APPLICATION OF NEW CINGULAR WIRELESS PCS, LLC (AT&T) FOR A CERTIFICATE OF ENVIRONMENTAL COMPATIBILITY AND PUBLIC NEED FOR THE CONSTRUCTION, MAINTENANCE AND OPERATION OF TWO TELECOMMUNICATIONS TOWER FACILITY LOCATED AT 1990 LITCHFIELD TURNPIKE IN THE TOWN OF WOODBRIDGE, CONNECTICUT

DOCKET NO. 388

AT&T RESPONSES TO SITING COUNCIL
PRE-HEARING INTERROGATORIES SET I

Current Coverage

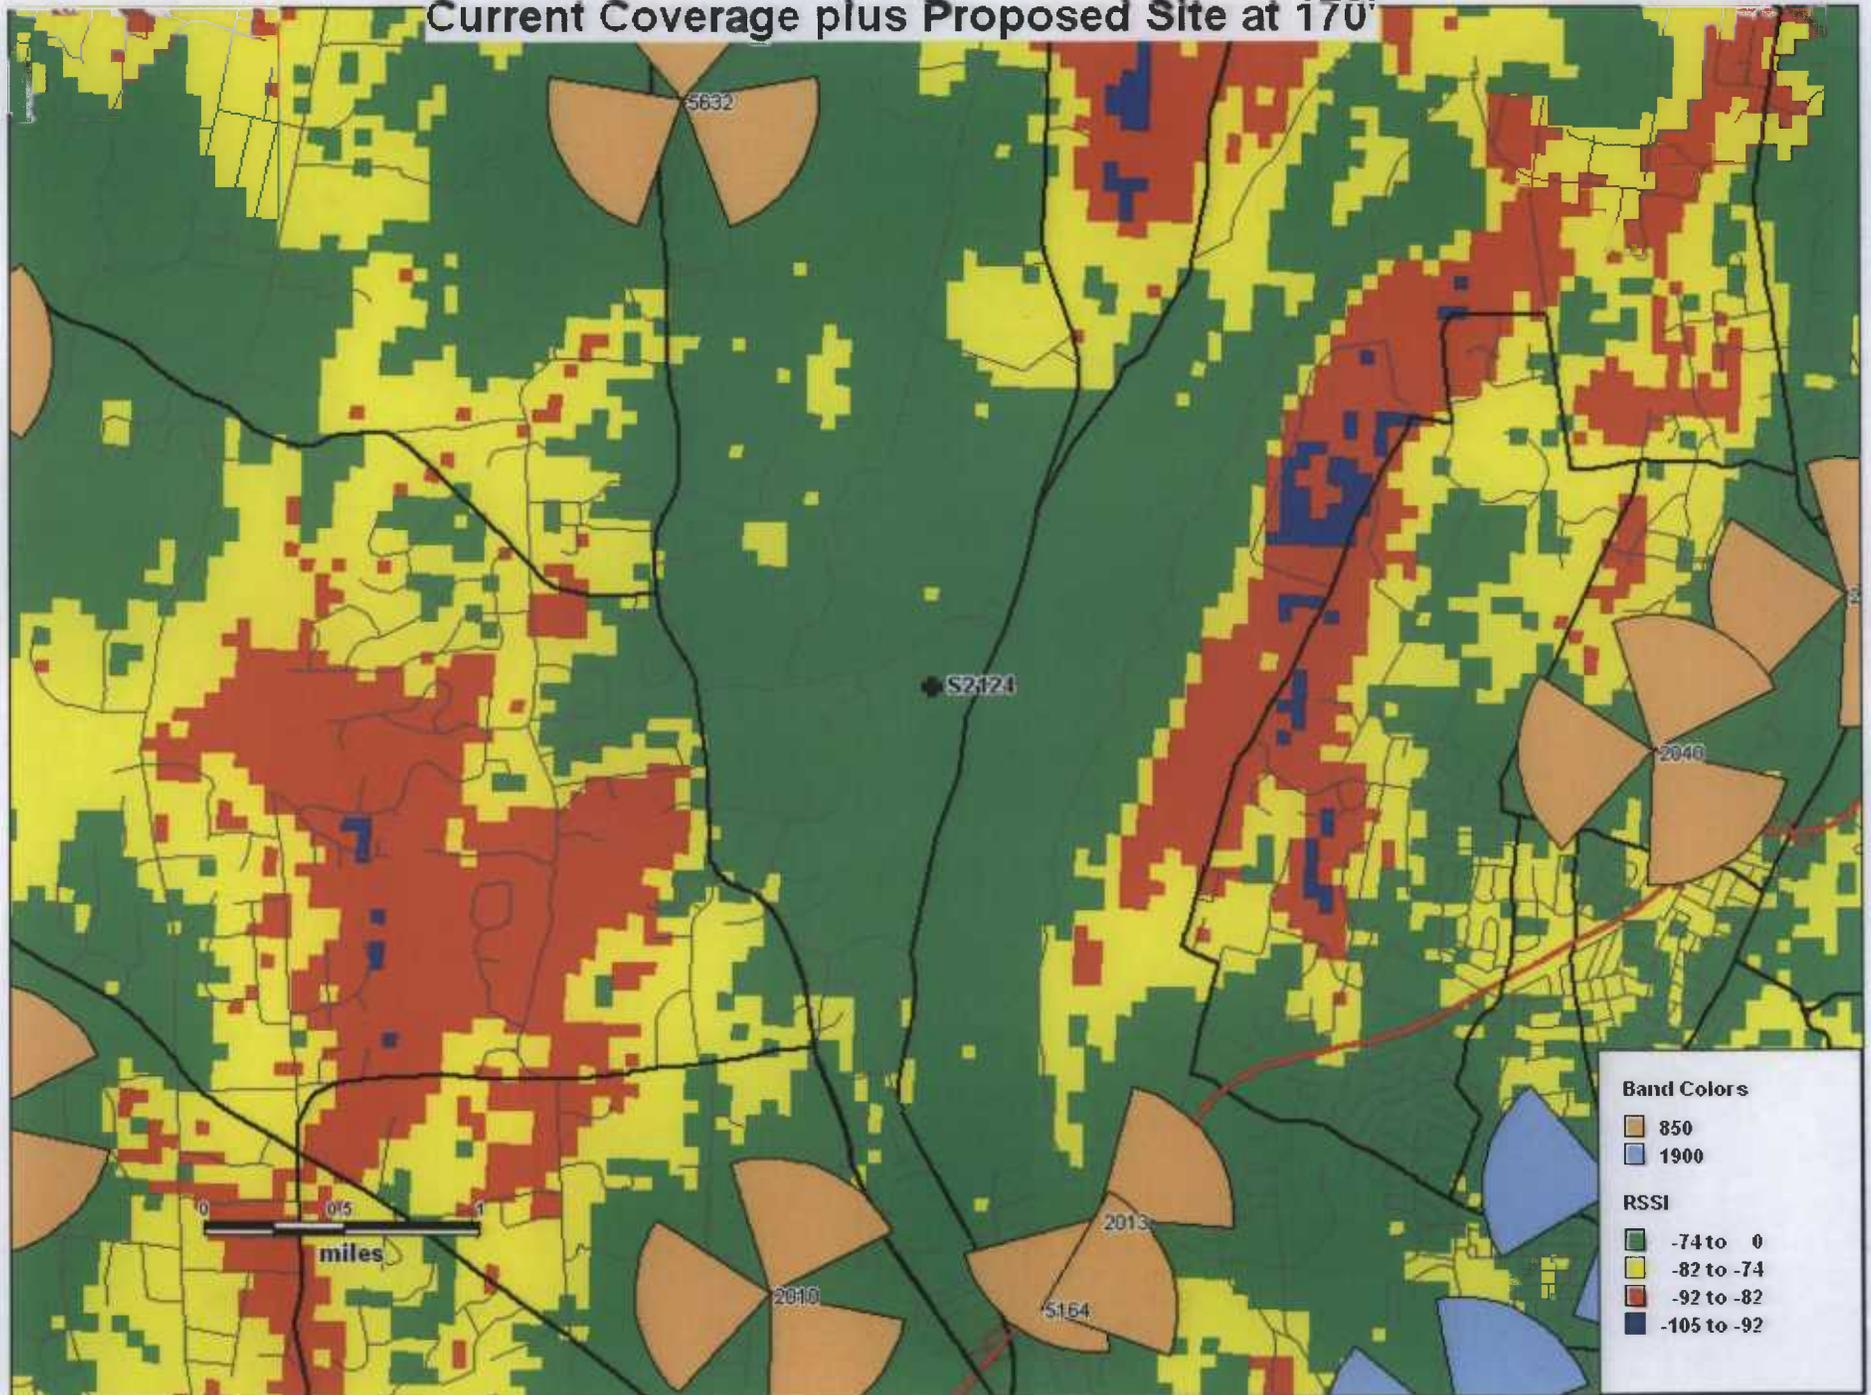
- Q12. Provide coverage plots for cellular and PCS, as applicable, using the same scale provided assuming the tower is 160 feet tall (with 157 foot antenna centerline height) and 150 feet tall (with 147 feet antenna centerline height), respectively.

- A12. Please see Attachment D which are coverage plots of AT&T's existing coverage as well as proposed cellular service that would be provided at tower heights of 150, 160 and 170 feet. Please note that all of these coverage plots were generated on December 11, 2009 in the interest of providing the most updated network information available and utilize the final 2-C certification coordinates. These replace all the plots filed in the original Application
